Appeal of an Administrative Decision to City Planning Commission

OLD RANCH ROAD STORAGE
Project Name

DEPN-22-0021
All File Numbers Associated with the Application

Appeal Amendment for DEPN-22-0021

LIGHT FIXTURE AND PHOTOMETRIC SITE PLAN

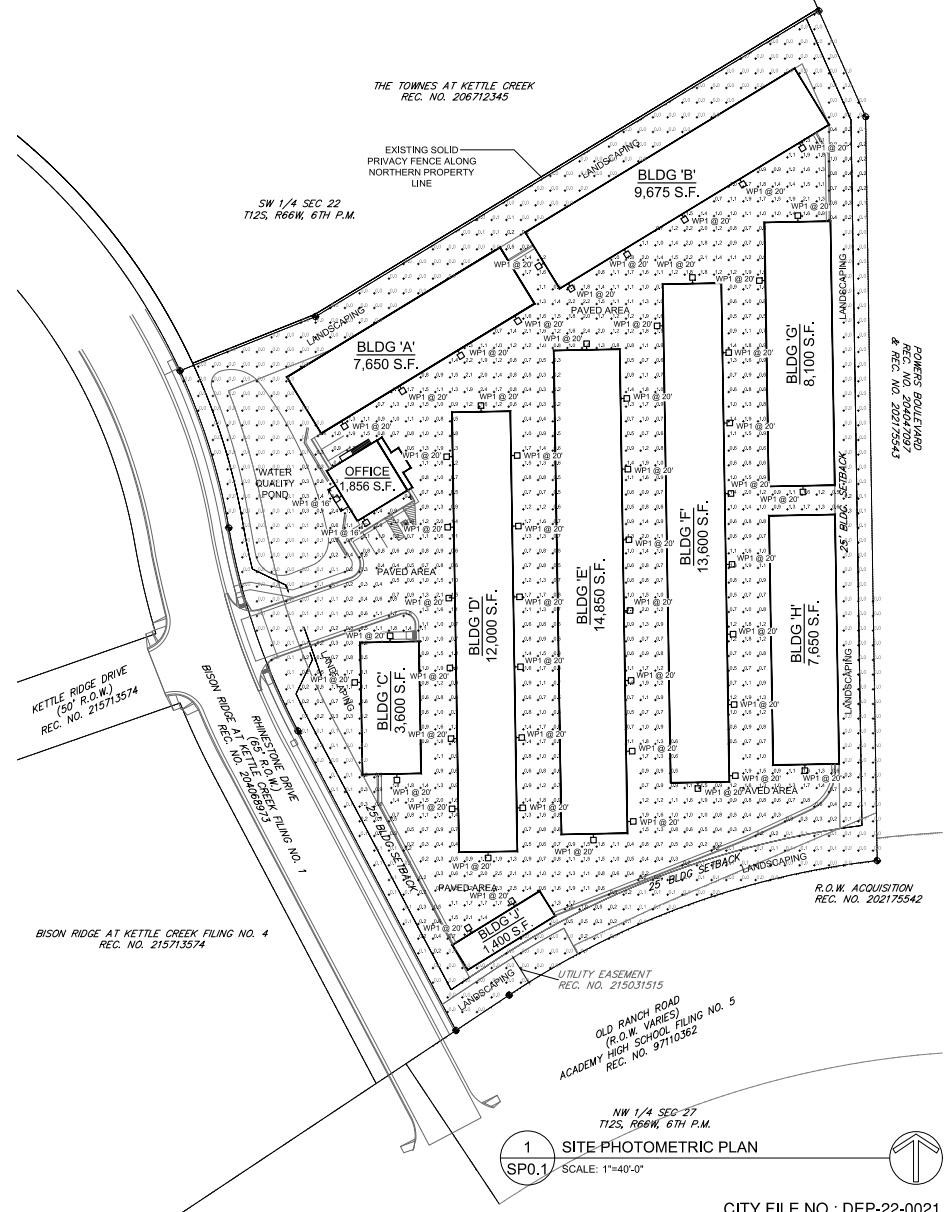
The applicant's lighting plan proposes the use of a variety of fixtures with a lumen output ranging from 1,000 to 3,000, all of which are downward-facing. However, it fails to specify the total quantity, placement, or cumulative photometric impact on the surrounding neighborhood. This omission is critical.

While individual fixtures may comply in isolation, the combined intensity of dozens of high-output lights, operating 24/7, represents a significant risk of light pollution, particularly to the adjacent residential properties to the north, west, and across Old Ranch Road.

Without a complete photometric study, including spillover analysis at the property boundaries, the City cannot accurately assess compliance with UDC requirements for site compatibility, buffering, and neighborhood protection.

Furthermore, the use of high-lumen commercial-grade lighting at the edge of a residential community is inherently incompatible with the quiet, low-light character of the surrounding area. At a minimum, the project must be required to:

- Submit a full lighting photometric plan,
- Implement shielded, low-glare fixtures, and
- Limit lighting operation hours to match restricted access hours.
